Access Compliance Report

Public Rights-of-Way

(Curb Ramps)

Intersection ID: 4973	Main Street: MALLARD_CREEK_RD	Cross Street: W_W_T_HARRIS_BV	Location:	N
ADA ID: 8E5BCB9486CD	Ramp Type: Perpendicular	Initial Pass/Fail: Fail	Overall Compliance: No	Severity Score: 22.5

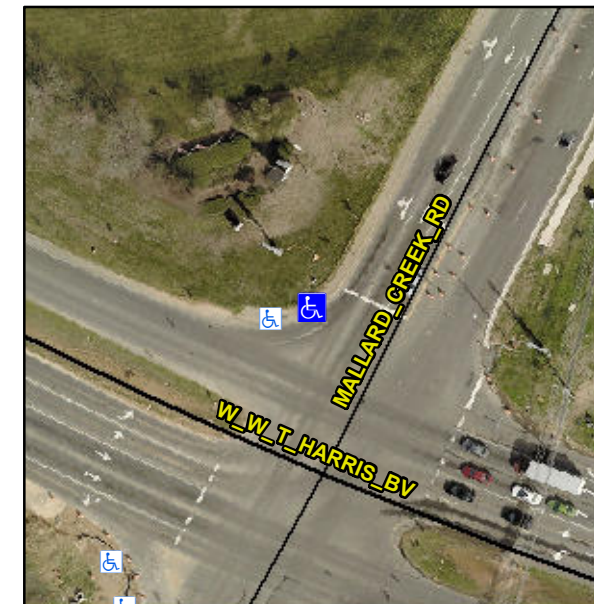
Not Found, R304.5.1, R304.2.2

Compliance	Description	Data	Compliance	Description	Data
N/A	Ramp Length (in)	63.0	No	Ramp Slope (%)	8.9
No	Ramp Width (in)	44.0	Yes	Ramp XSlope (%)	2.1
N/A	Flare Type LT	N/A	N/A	Flare Type RT	N/A
N/A	Flare Slope LT (%)	N/A	N/A	Flare Slope RT (%)	N/A
N/A	Flare Traversable LT?	N/A	N/A	Flare Traversable RT?	N/A
N/A	Landing Length (in)	N/A	N/A	DWS Provided?	N/A
N/A	Landing Width (in)	N/A	N/A	DWS Contrast?	N/A
N/A	Landing Slope (%)	N/A	N/A	DWS Length (in)	N/A
N/A	Landing X Slope (%)	N/A	N/A	DWS Full Width?	N/A
N/A	Landing Curb? (Y/N)	N/A	N/A	DWS Offset (in)	N/A
N/A	Shared Landing?	N/A			
N/A	Gutter Ponding?	N/A	N/A	Gutter Slope (%)	N/A
N/A	Gutter Lip Ht (in)	N/A	N/A	Gutter X Slope (%)	N/A
N/A	Painted X Walk1?	No	N/A	Painted X Walk2?	N/A
	X Walk 1 Direction	To E		X Walk 2 Direction	N/A
N/A	X Walk 1 Width (in)	N/A	N/A	X Walk 2 Width (in)	N/A
	X Walk 1 Slope (%)	1.0		X Walk 2 Slope (%)	N/A
	X Walk 1 X Slope (%)	2.8		X Walk 2 X Slope (%)	N/A

Remove & Replace Entire Ramp.
